**Oakland City Planning Commission
Design Review Committee**

STAFF REPORT

Case File Number: PLN17101

Project Location:	10 10 th Street (Oakland Civic Auditorium)
Assessor's Parcel Numbers:	018 045000500
Proposal:	To rehabilitate the vacant Oakland Civic Auditorium that consists of interior and exterior building alterations, including site modifications to the walkways, landscaping and parking lot in order to facilitate new commercial uses and upgrade the entertainment venues.
Project Applicant/ Telephone:	Orton Development, Inc. (510) 428-0800
Property Owner:	City of Oakland
Case File Number:	PLN17101
Planning Permits Required:	Major Conditional Use Permit for Extensive Civic Impact; and Regular Design Review for site and building alterations.
General Plan: Specific Plan:	Central Business District Lake Merritt Station Area District
Zoning:	D-LM-4 Lake Merritt Station Area District Mixed Commercial
Environmental Determination:	Under Review
Property Historic Status:	OCHS A1+, Designated Historic Property API, Area of Primary Importance (Lake Merritt)

2 NORTH ELEVATION - PROPOSED
1" = 30'-0"

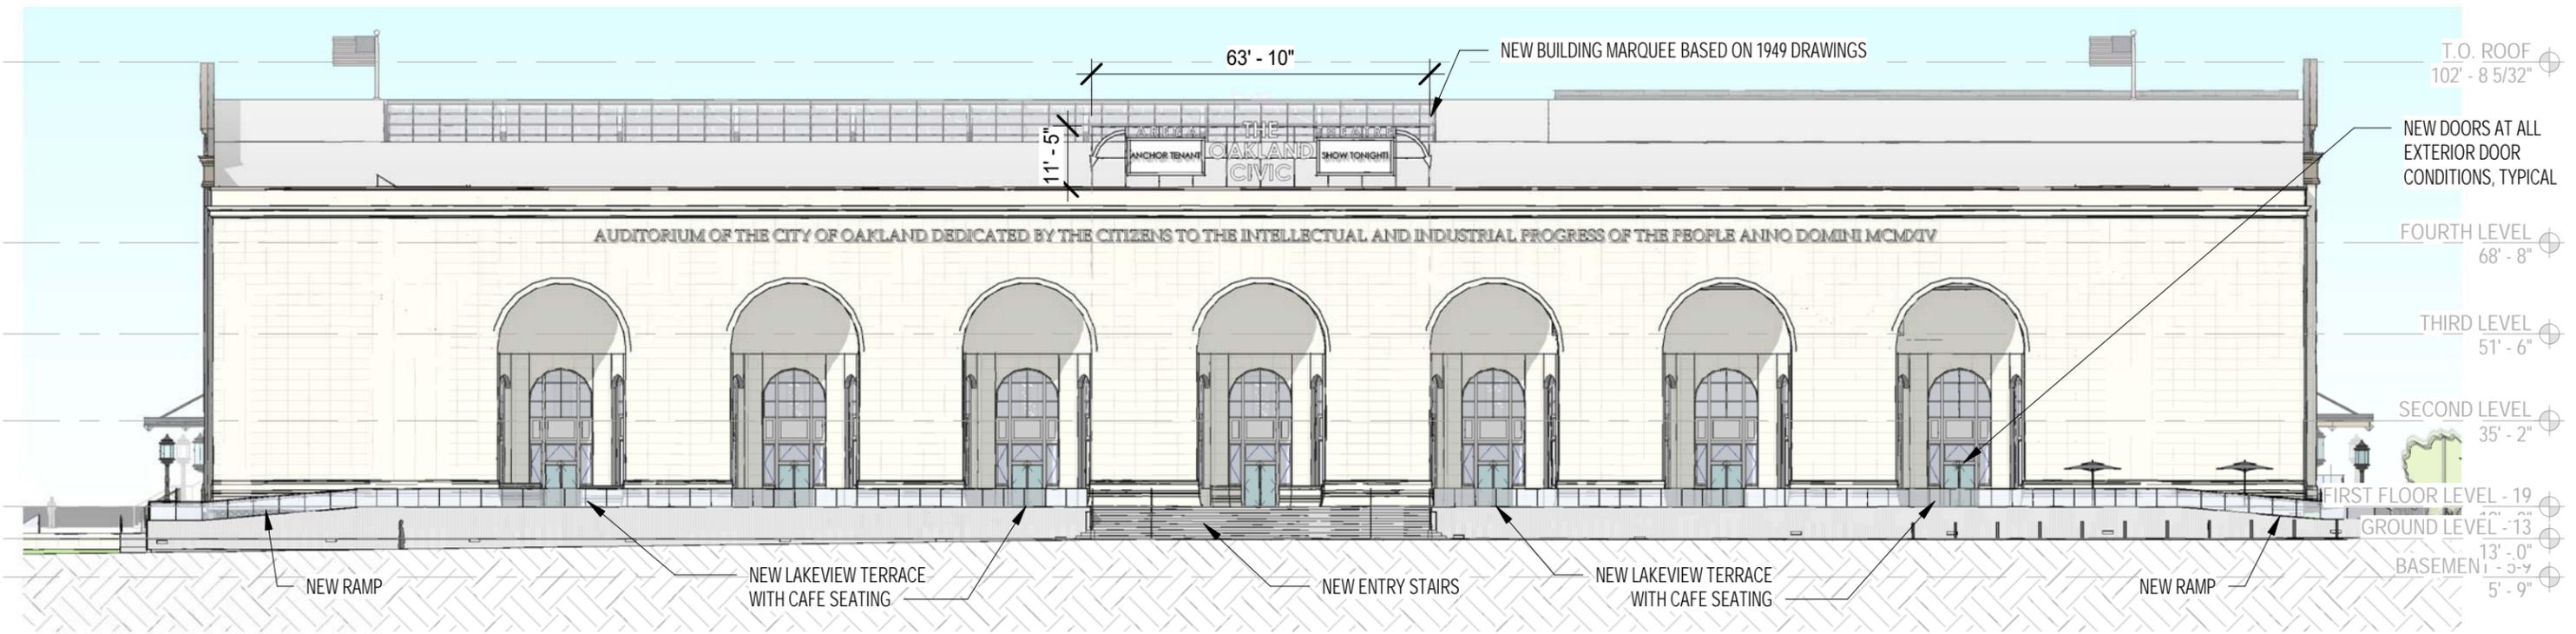
The Oakland Civic Auditorium is considered a City Landmark because of its significant historical, architectural and cultural value. The proposal would replace the north concrete entries of the OCA with a raised terrace that extends approximately 400 feet along façade of the building. The seven-foot tall concrete terrace with a three and one-half foot tall glass guardrail would potentially visually obstruct the lower area of the prominent arched niches and entry stairs when viewed from Lake Merritt Boulevard and the Lake Merritt shore. Staff believes that the proposal would create an unnecessary impairment of the physical features that contribute to highest level of recognition of historic significance for the OCA..

Staff would support a plan for a larger terrace in front of the OCA if it is built at grade. The applicant may consider building a forecourt between the building and the parking lot. The forecourt would include a wider entry pathway that connects OCA from Lake Merritt Boulevard. The forecourt and pedestrian pathway could include distinctive paving materials, landscape barriers or planters, outdoor furniture, and bollard lights to create a separation from the parking lot.

- Replace the raised terrace with one that is at grade level.
- Place the new terrace access ramps at the ends of the front building.
- Provide a simple and subtle design to the surface parking.
- Make the pathway entry in the parking lot more prominent.
- Clarify the pathway from the promenade to Lake Merritt Boulevard.
